UNITED STATES PATENT AND TRADEMARK OFFICE

APPLICATION NO.	FILING DATE	FIRST NAMED INVENTOR	ATTORNEY DOCKET NO.	CONFIRMATION NO.
10/633,557	08/05/2003	Kaoru Sato	43890-618	7144
7590	03/27/2006		EXAMINER	
MCDERMOTT, WILL & EMERY 600 13th Street, N.W. WASHINGTON, DC 20005-3096			LEO, LEONARD R	
			ART UNIT	PAPER NUMBER
			3753

Office Action Summary

DETAILED ACTION

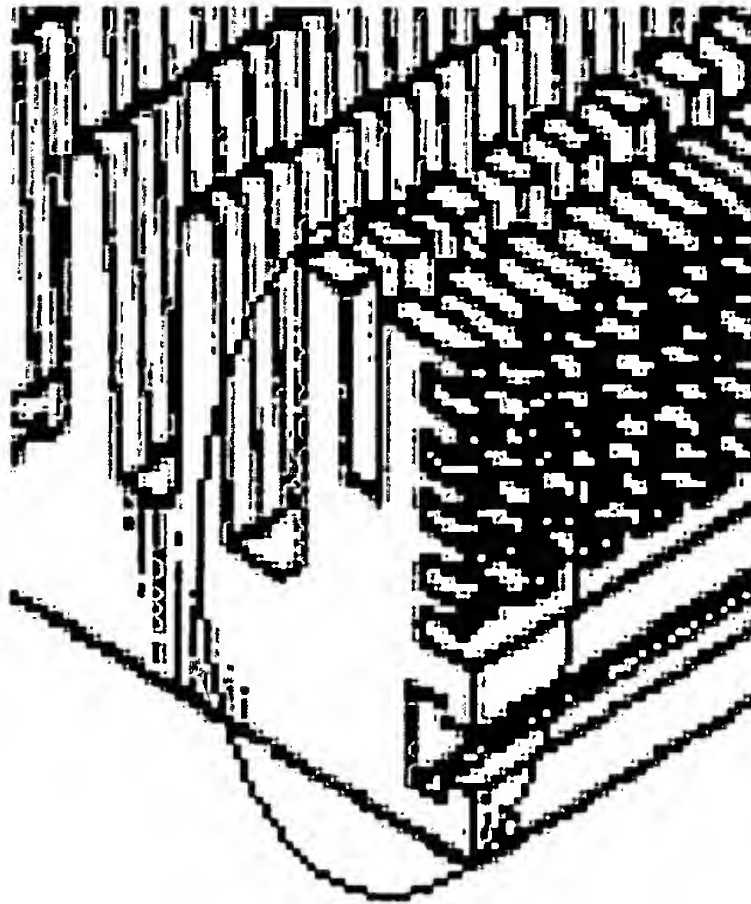
Claim 29 is rejected under 35 U.S.C. 102(b) as being anticipated by Jordan et al. As shown on the following page, Jordan et al (circled region) discloses a column having a perpendicular side face with respect to the heat receiving face, a plurality of fins parallel to the heat receiving face, and blower 11 mounted thereon.
